## **Lafayette Square**

Accessibility Review

City of Duluth, MN

2013

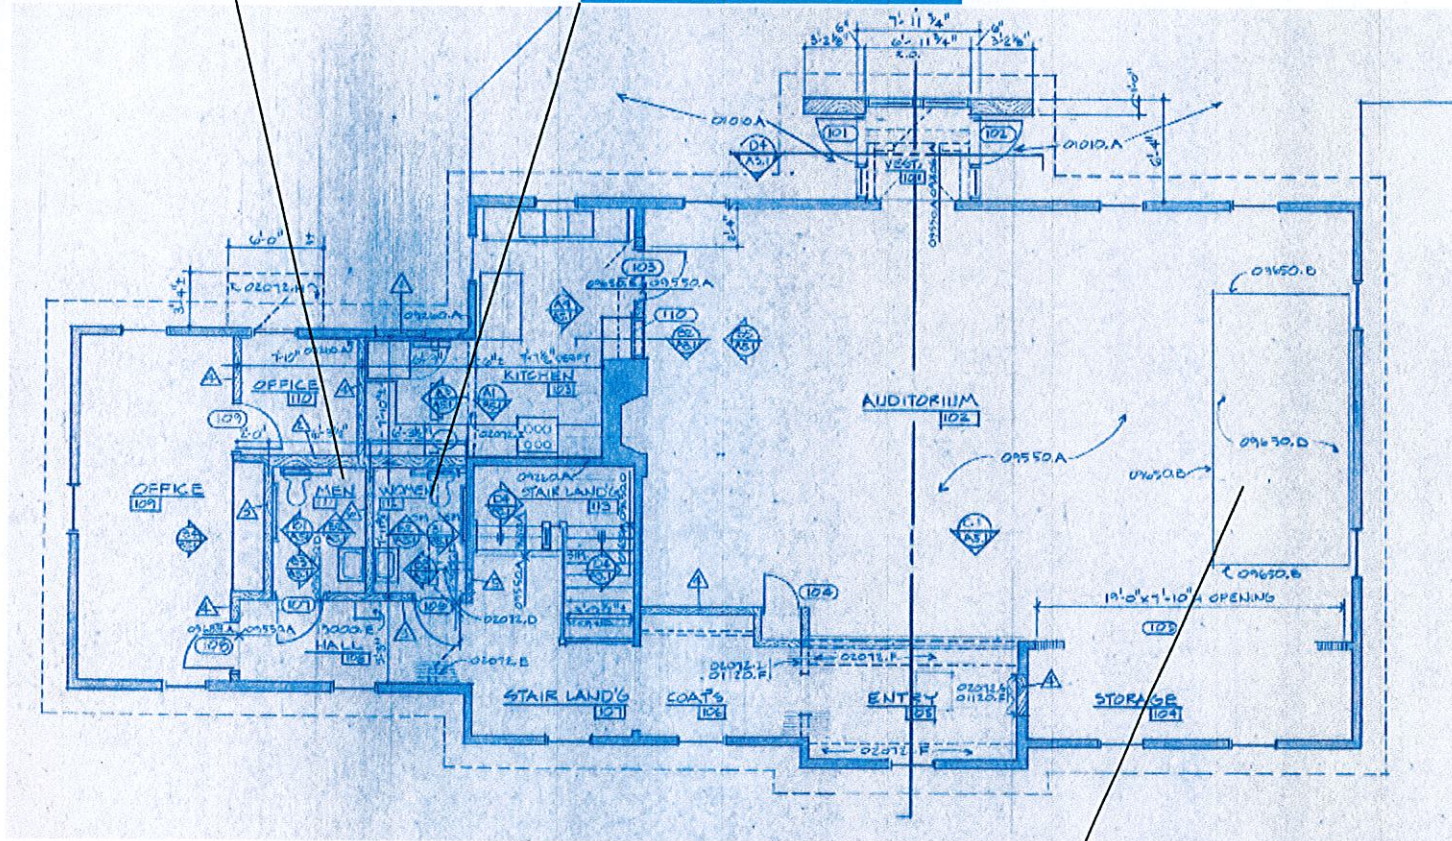
Install vertical grab bar  
 Insulate pipes at lavatory  
 Add raised and braille sign  
 Add a full height mirror

Install vertical grab bar  
 Insulate pipes at lavatory  
 Relocate sanitary waste receptacle  
 Add raised and braille sign  
 Add a full height mirror

Bevel rise between asphalt and deck to beach

Parking  
 Re-stripe faded accessible parking spaces

Provide a ramp up to the stage

Install door lever hardware
